BUILDING CODE OF AUSTRALIA COMPLIANCE ASSESSMENT REPORT FOR DA SUBMISSION

MIXED USE DEVELOPMENT COMPRISING OF 4 BUILDINGS

93-107 CECIL AVENUE AND 9-10 ROGER AVENUE, CASTLE HILL

REPORT NO. ► 13685 Rev. 01

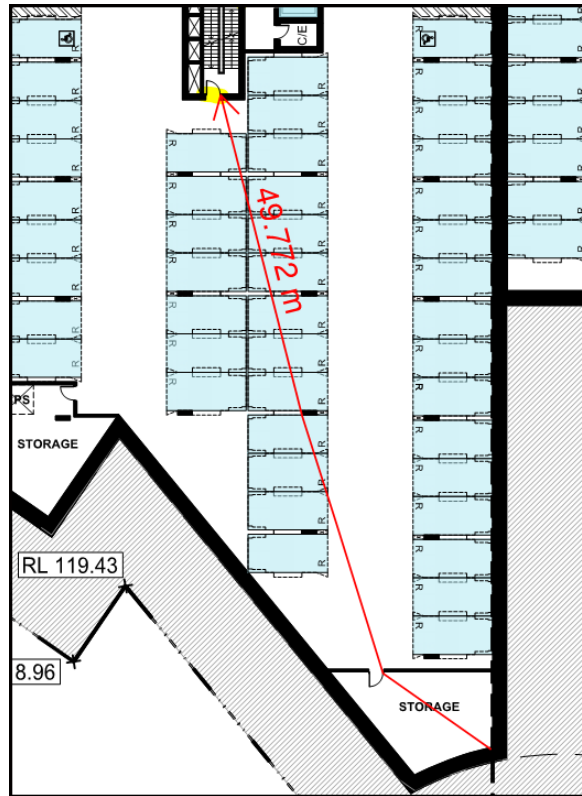
Basement 2: More than 20m to a point of choice to an exit (circa 60.7m).

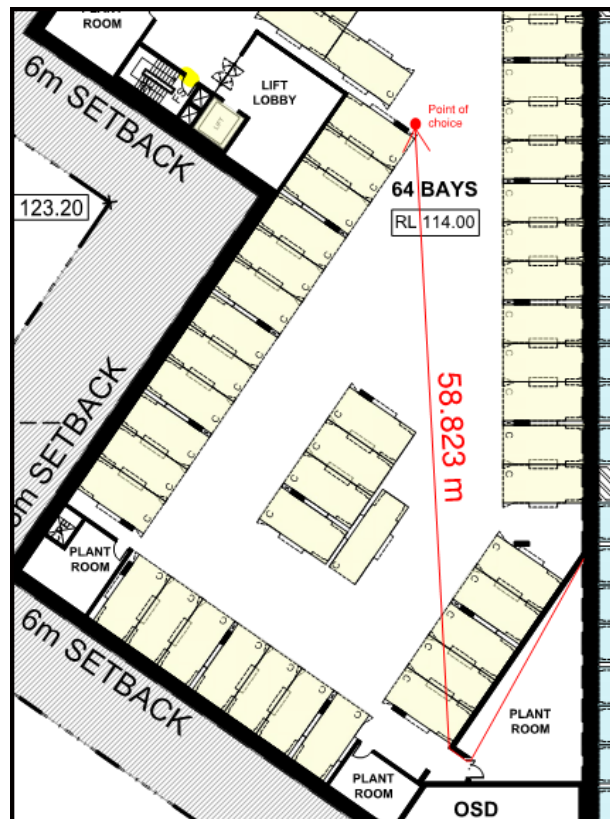
Basement 2: More than 40m to one exit (circa 49.7m).

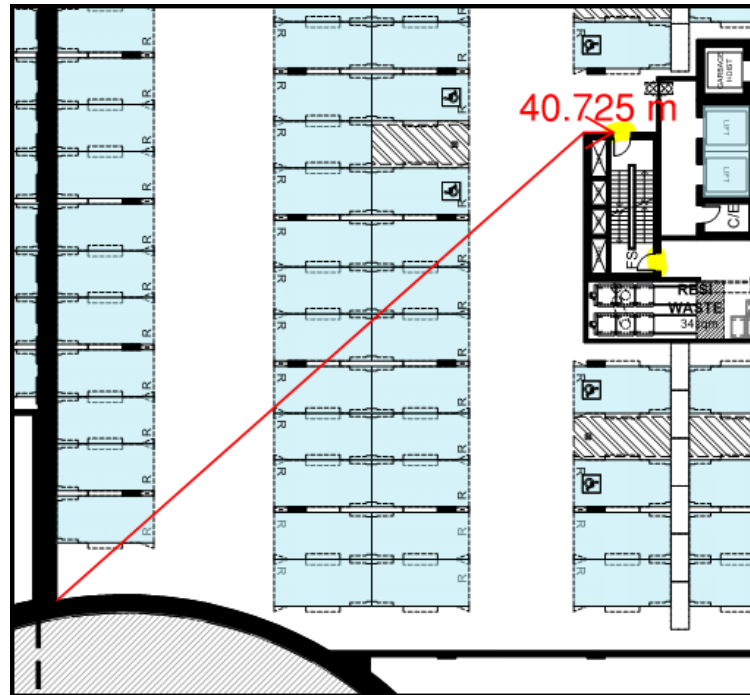
Basement 1: More than 20m to a point of choice to an exit (circa 58.8m).

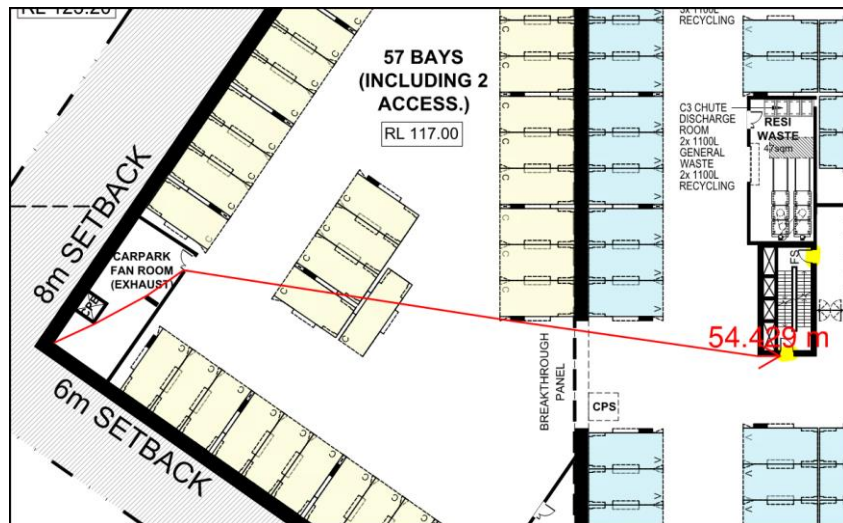
Basement 1: More than 40m to one exit (circa 40.7m).

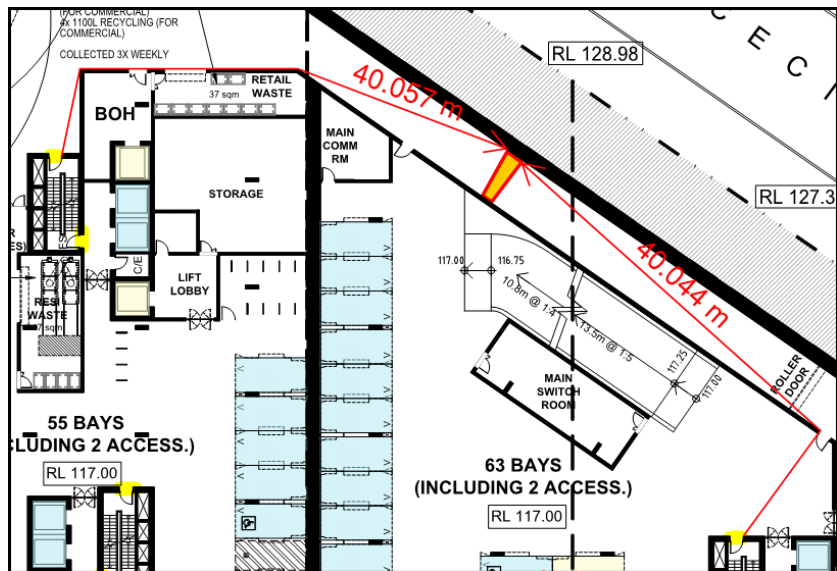
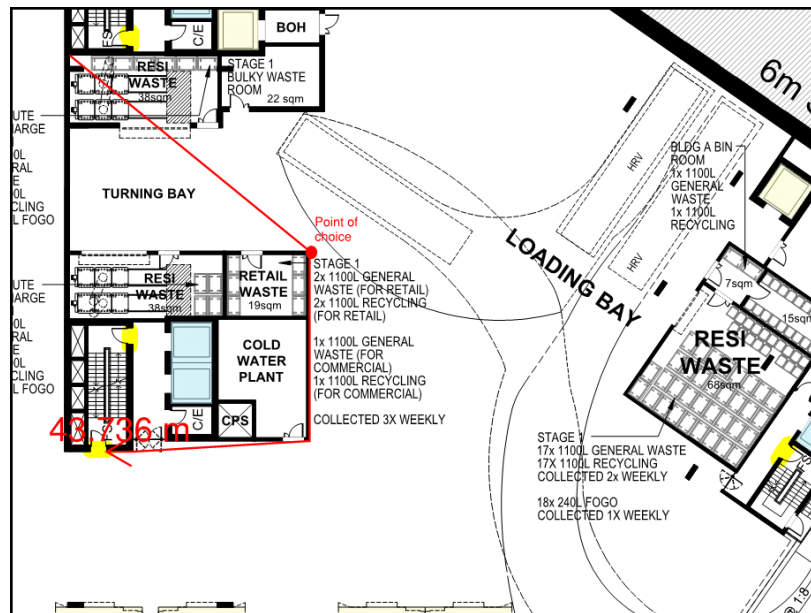
Lower Ground: More than 40m to one exit (circa 54.5m).

Lower Ground: More than 40m to one exit (non-complaint areas highlighted).

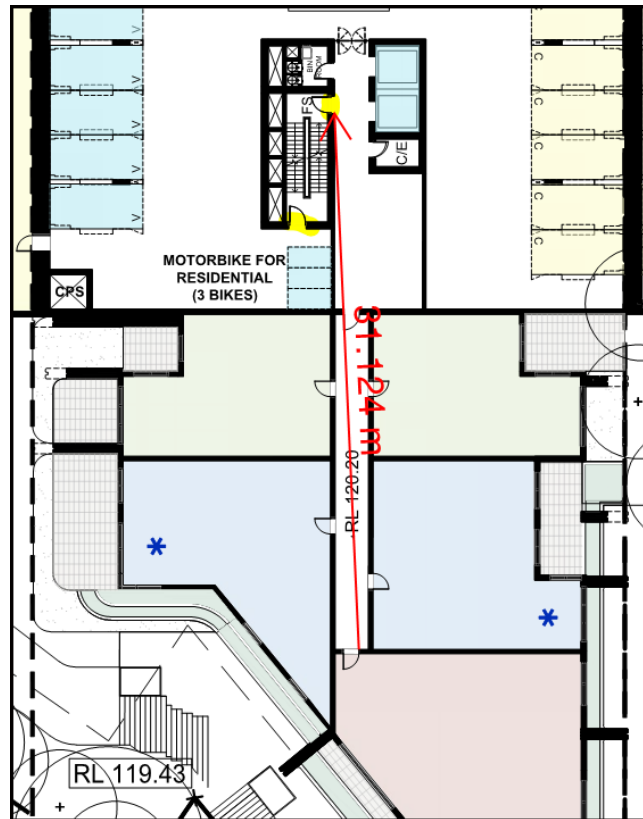
Lower Ground: More than 40m to one exit (circa 43.7m).

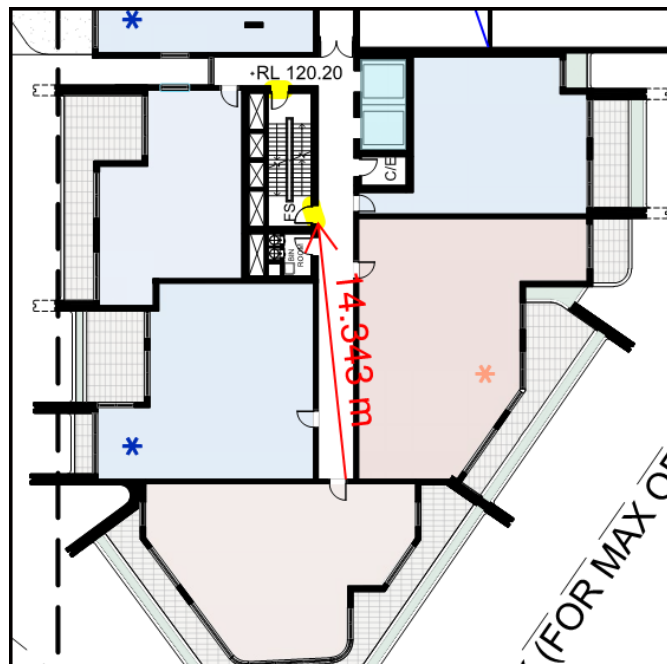
Ground: More than 6m from an exit or a point of choice (worst case circa 31.1m) and more than 20m from an exit or a point of choice for an area not within a SOU (worst case circa 31.1m).

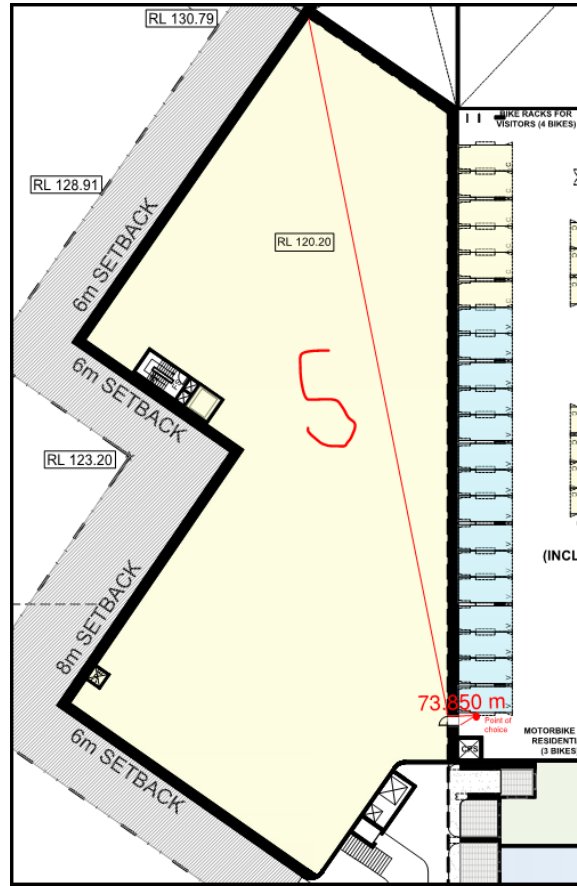
Ground: More than 6m from an exit of a point of choice (worst case circa 14.3m).

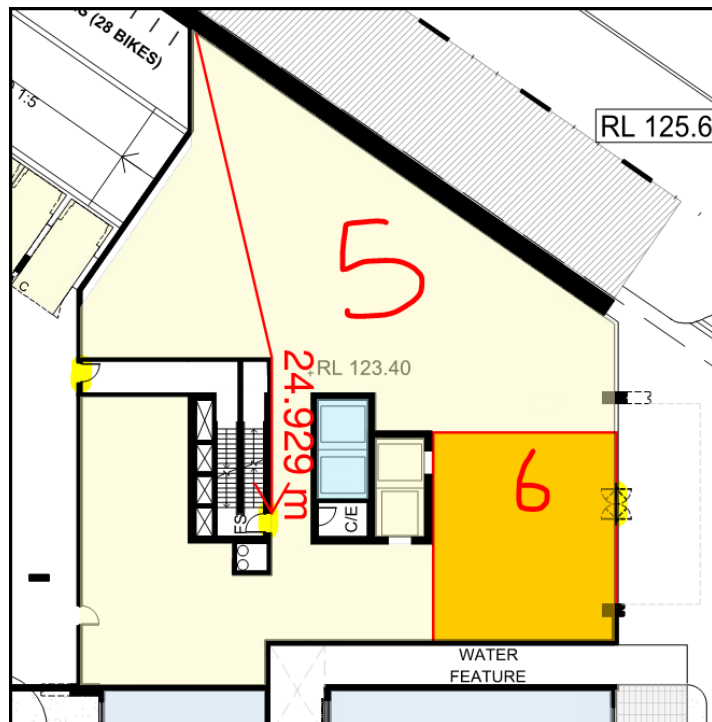
Ground: More than 20m to a point of choice (circa 73.8m) and more than 40m to a single exit (circa 85.9m)

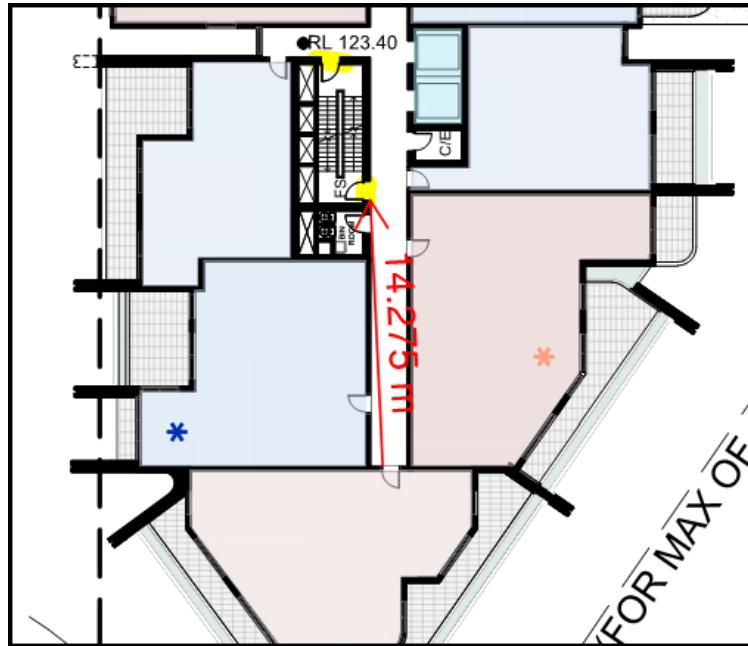
Upper Ground: More than 20m to single exit (circa 24.9m)

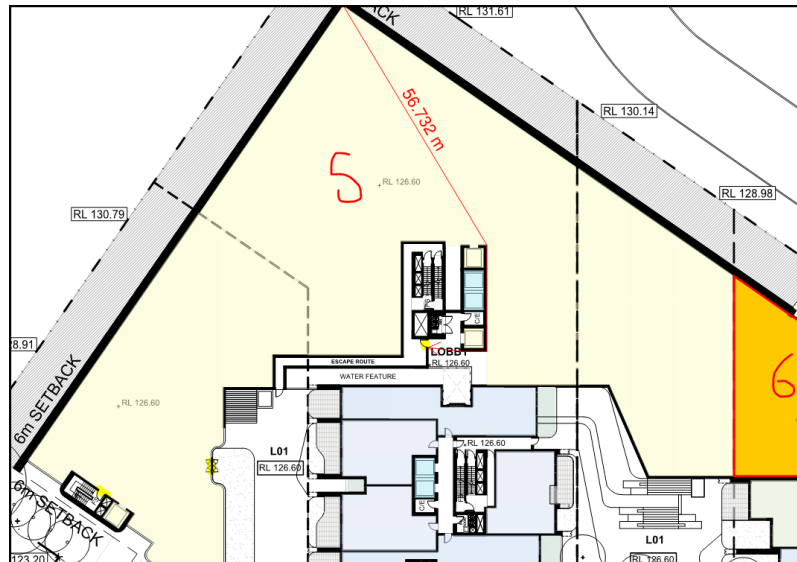
Upper Ground: More than 6m to a single exit or a point of choice (worst case circa 14.2m)

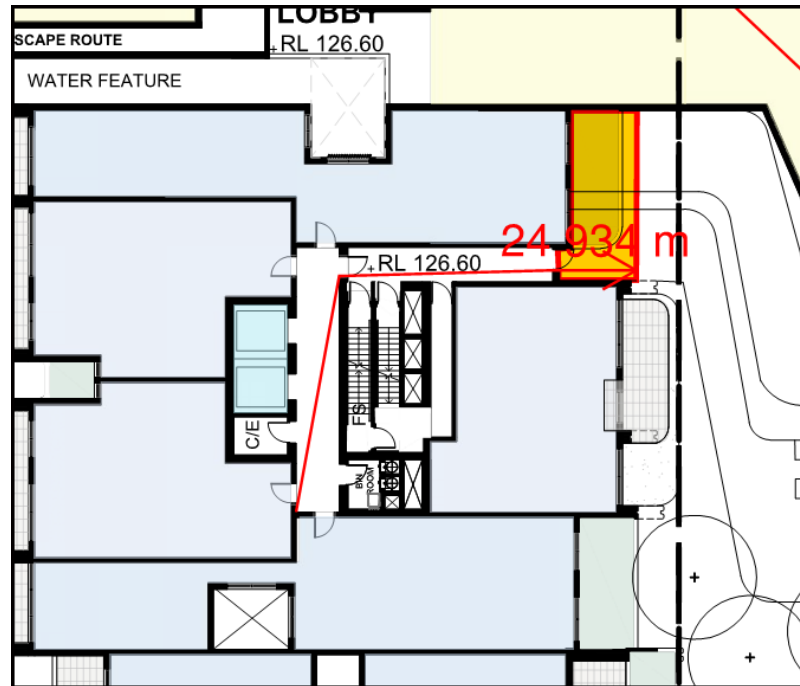
Level 1: More than 40m to an exit (circa 56.7m).

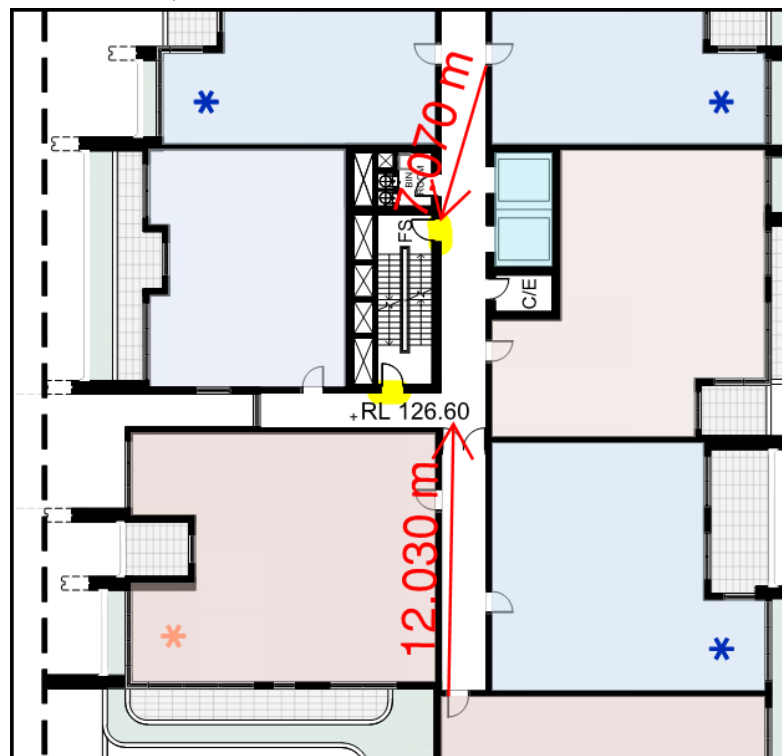
Level 1: More than 20m from an exit or a point of choice (worst case circa 24.8m) and more than 20m from an exit or a point of choice for an area not within a SOU (worst case circa 24.9m).

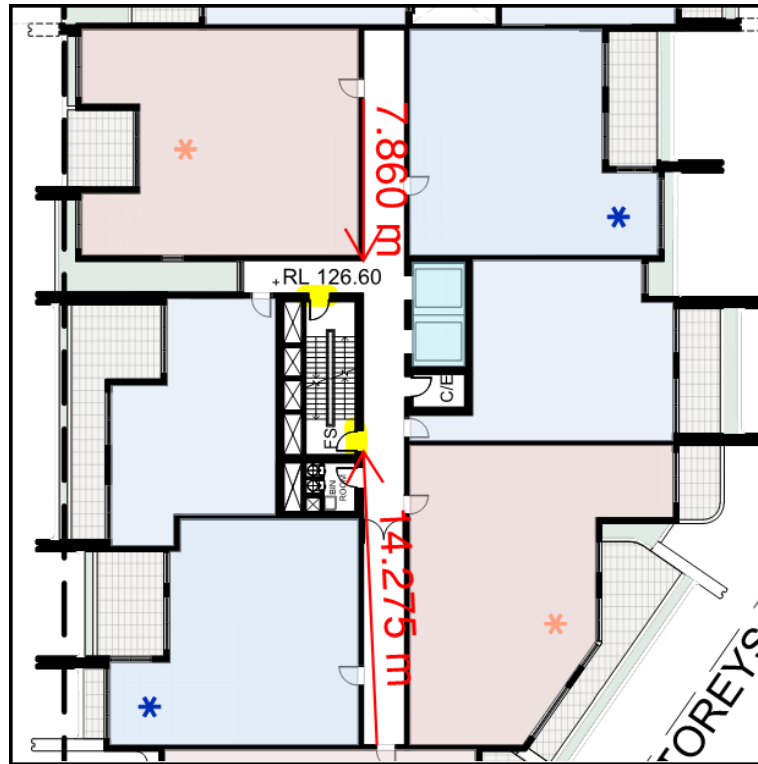
Level 1: More than 6m to a single exit (worst case circa 7.0m) or to a point of choice (worst case circa 12.0m).

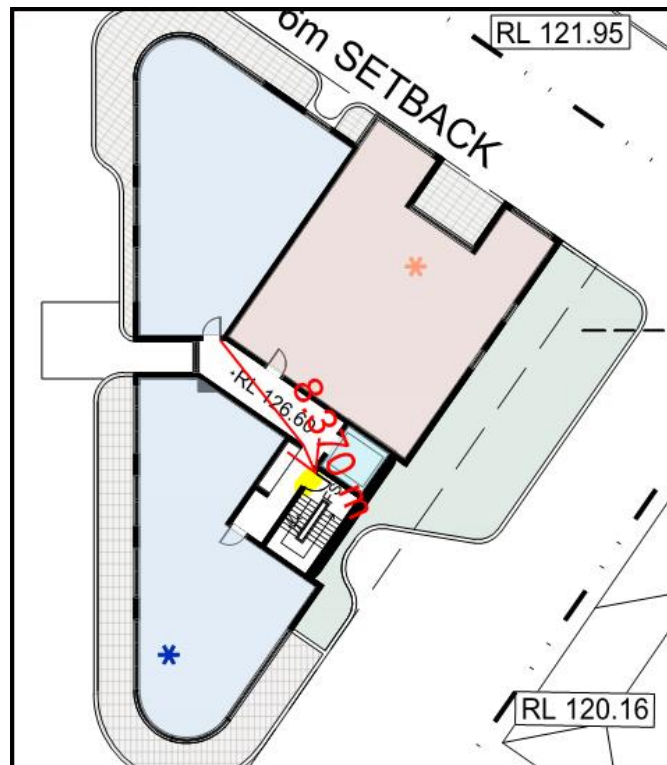
Level 1: More than 6m to a point of choice (worst case circa 14.2m).

Level 1: More than 6m to a single exit (worst case circa 8.3m).

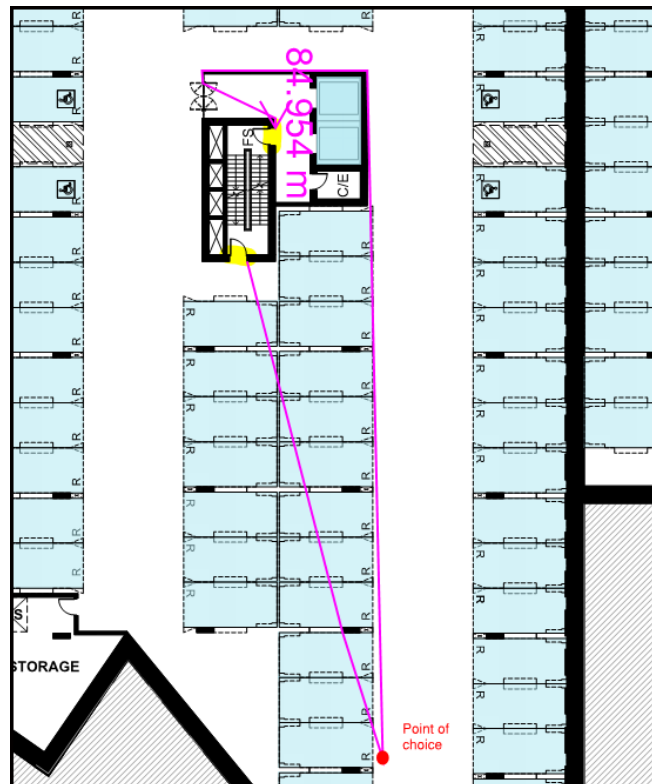
Basement 2: The distance between the alternative exits exceeds 60m (circa 70.9m)

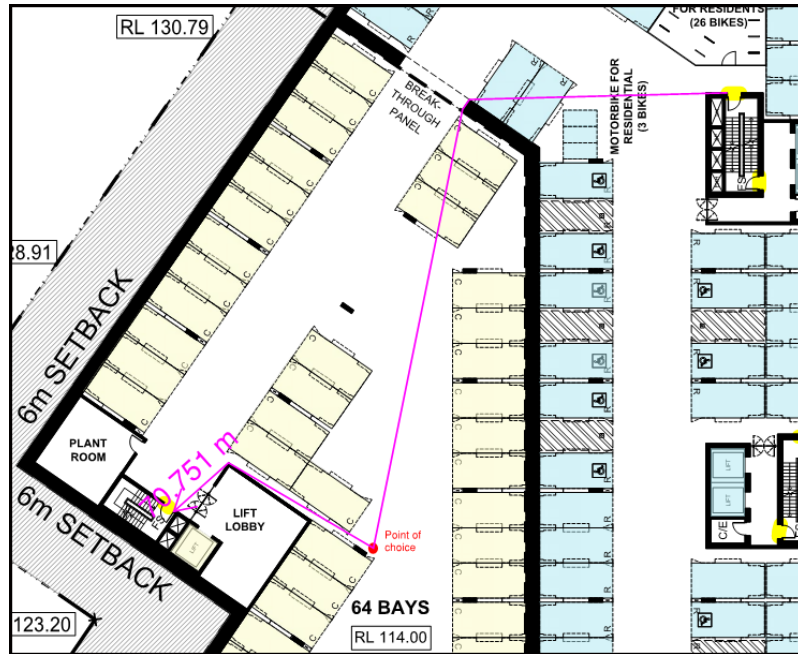
Basement 2: The distance between the alternative exits exceeds 60m (circa 84.9m)

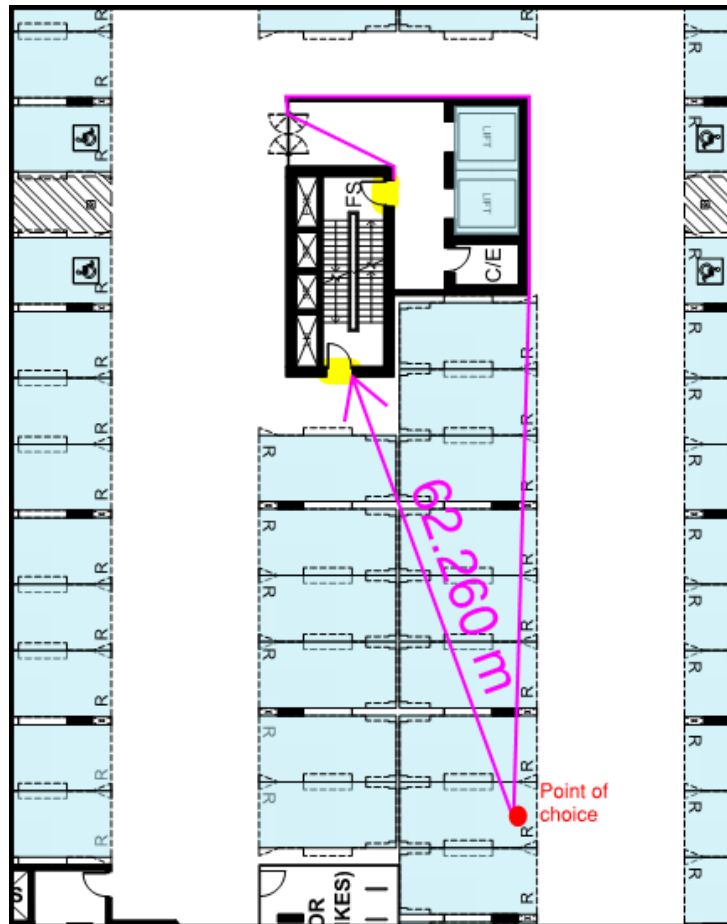
Basement 1: The distance between the alternative exits exceeds 60m (circa 70.5m)

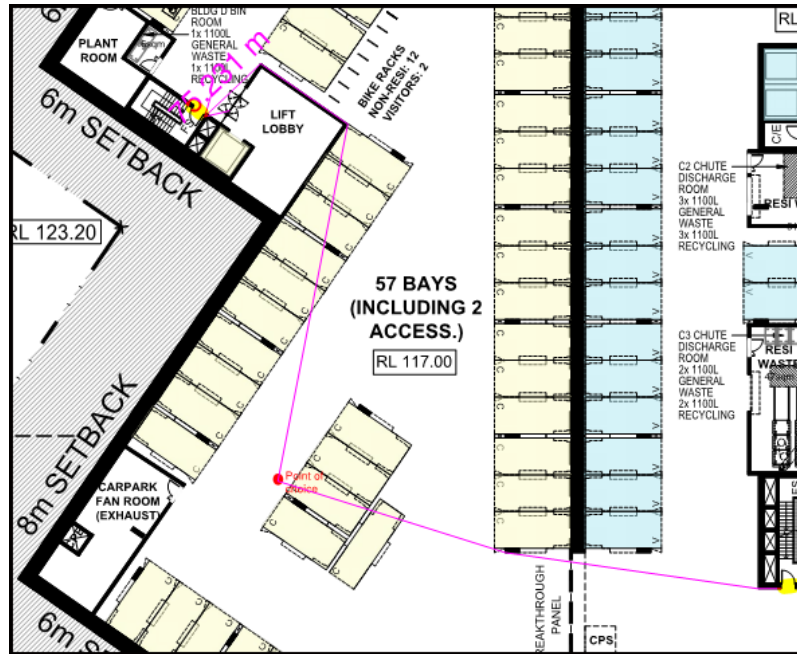
Basement 1: The distance between the alternative exits exceeds 60m (circa 62.6m)

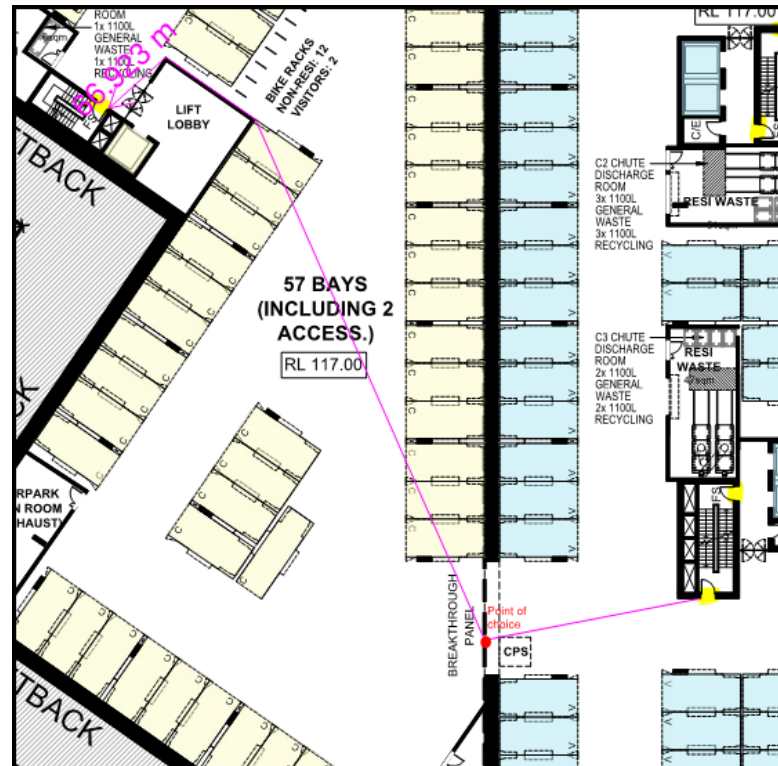
Lower Ground: The distance between the alternative exits exceeds 60m (circa 75.2m)
